UNITED STATES PATENT AND TRADEMARK OFFICE

APPLICATION NO.	FILING DATE	FIRST NAMED INVENTOR	ATTORNEY DOCKET NO.	CONFIRMATION NO.
09/703,282	10/31/2000	Vadim Gektin	Sun-P5363	2267

Office Action Summary

DETAILED ACTION

Figure A: The modified figure corresponds to figure 2 with some limitation shown.

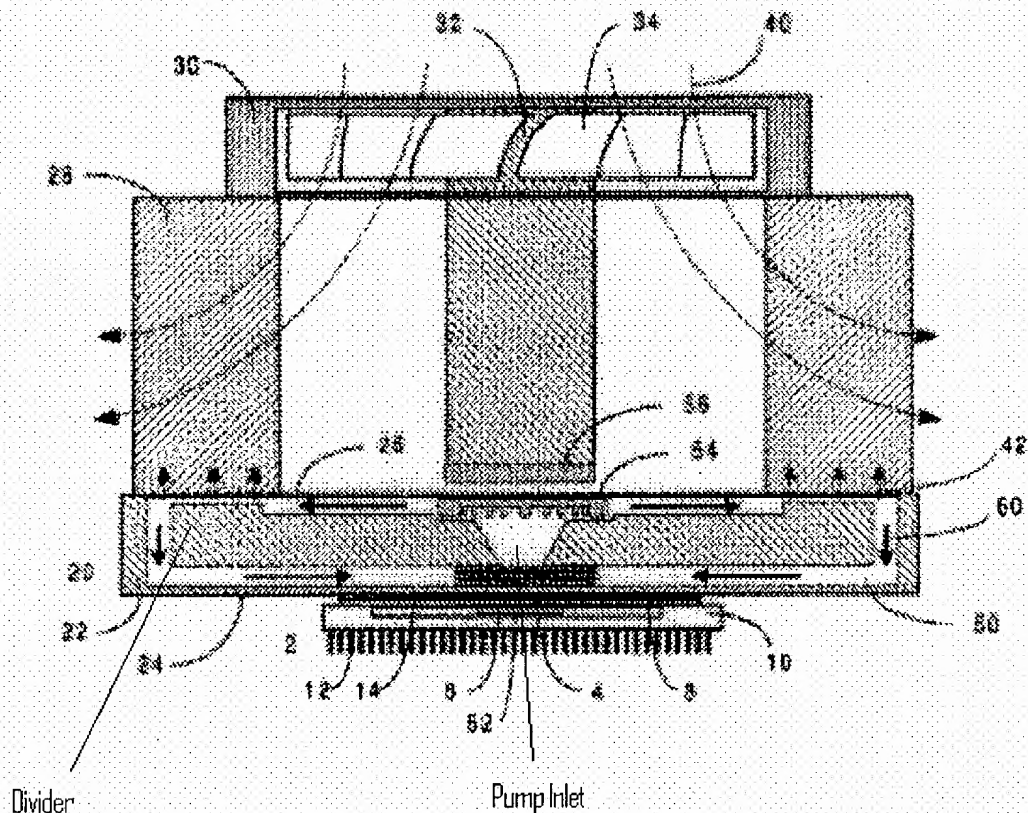
Claims 1,2,4-5 and 8-17 are rejected under 35 U.S.C. 103(a) as being unpatentable over Batchelder (US 6,019,165) in view of Batchelder (US 6,175,495) and Dodson (US 5,787,971). Batchelder discloses (figures 2,7,8 and Figure A as bellow) a liquid heat sink comprising an aluminum or copper base (20) having a first surface (24) and a second surface (26); the first surface being configured to be in contact with the heat source; a plurality of fins (28) extending from the second surface; the base including a chamber disposed between the first and second surfaces (24,26); the chamber including a divider (206) disposed with the chamber and between the first and second surfaces; a pump, which includes components such as fan (30), magnet (56) and impeller (54), approximate to an upper edge of the base (20); an inlet of the pump (as indicated in the Figure A) being proximate the first surface of the base to receive a cooling fluid such as water disposed within the chamber; an outlet pump proximate to the second surface and

configured to pump the cooling fluid over the second surface; and a fan (30) attached to the fins.

Batchelder further discloses (figures 7 and 8) that the divider (206,210) including a plurality of flow dividers (222,226,234) extending radially from the pump to maximize heat transfer from the fluid to the fins.
